SUBJECT: COMANCHE PEAK STEAM ELECTRIC STATION
DOCKET NOS. 50-445 AND 50-446
SUPPLEMENT TO LICENSE AMENDMENT REQUEST (LAR) 07-004
REVISION TO THE OPERATING LICENSE AND TECHNICAL SPECIFICATION 1.0,
"USE AND APPLICATION" TO REVISE RATED THERMAL POWER FROM 3458 MWT
TO 3612 MWT
(TAC NOS. MD6615 AND MD6616)

RESPONSE TO REQUEST FOR ADDITIONAL INFORMATION

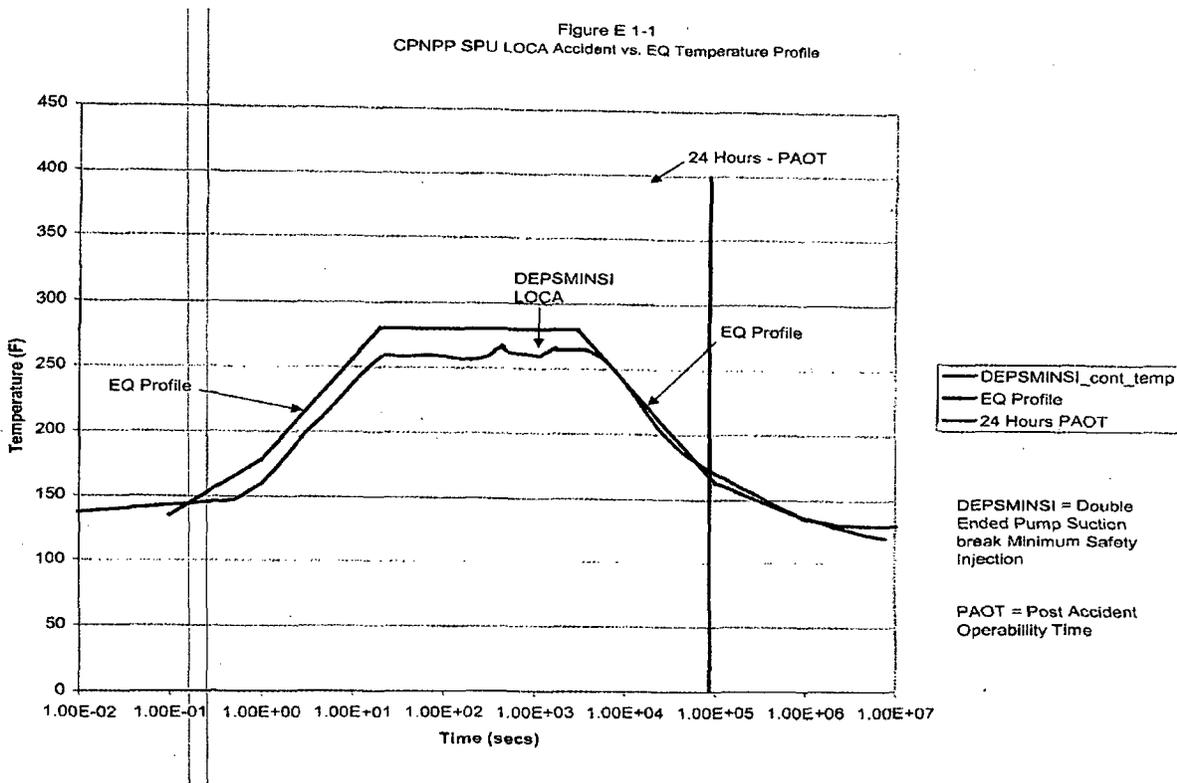
In Section 2.3.1.2.2 of the SPULR, "Inside Containment," it is stated that at SPU, the containment analysis of design basis accidents (DBAs) demonstrates that the equipment qualification (EQ) for peak temperature remains bounded by the current EQ profile. However, the long-term temperature slightly exceeds the current profile at limited time later in the transient after the peak temperature has been reduced.

Provide details of the long-term temperature impact and the temperature evaluation done for DBA conditions.

The peak SPU LOCA temperature of 266.1 degrees Fahrenheit (°F) is reached at approximately 446 seconds (DEPSMINSI curve on Figure E 1-1 below). As shown on Figure E 1-1, a new EQ profile has been issued that extends the time duration at 280 °F so that it envelopes the new SPU LOCA curve and specifically the area that had exceeded the old EQ profile. This new EQ profile is being added to the EQ Packages as part of the CPNPP EQ package update using the plant EQ procedure. The PAOT impact is minor, since there is only a 7 °F difference between the SPU LOCA curve (170 °F) and the intersection point of the EQ profile (163 °F) at the 24 hour mark.

Siemens Power Generation Updated Main Generator Capability Curve

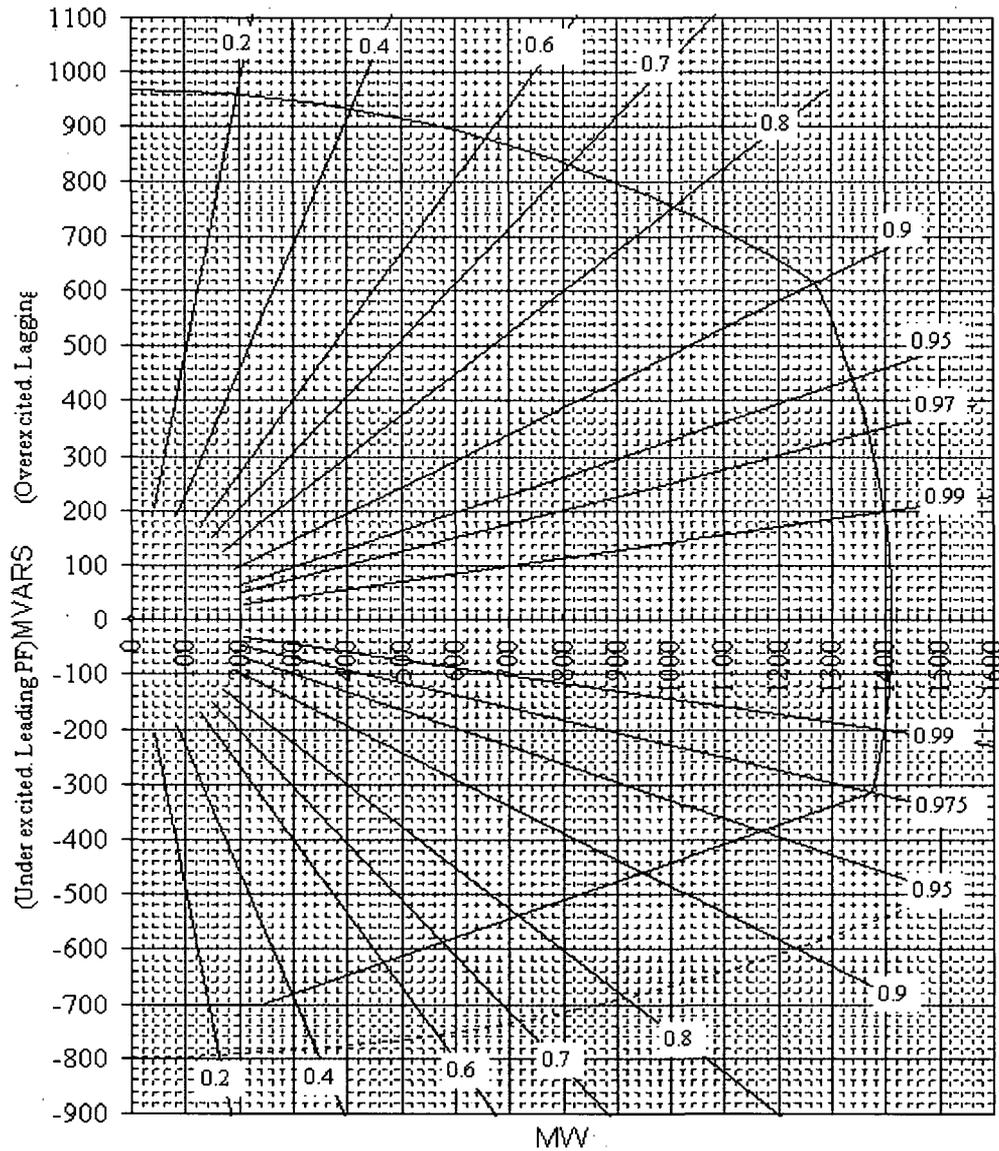
Provide the nominal or approximate megawatt generation of the CPSES units before and after the SPU. Provide a copy of the updated main generator capability curve.

Also, please find below the Siemens Power Generation updated Main Generator capability curve.

————— Capability curve for new rated output 1410 MVA, 0.9 PF, 22 KV, 65 PSIG.
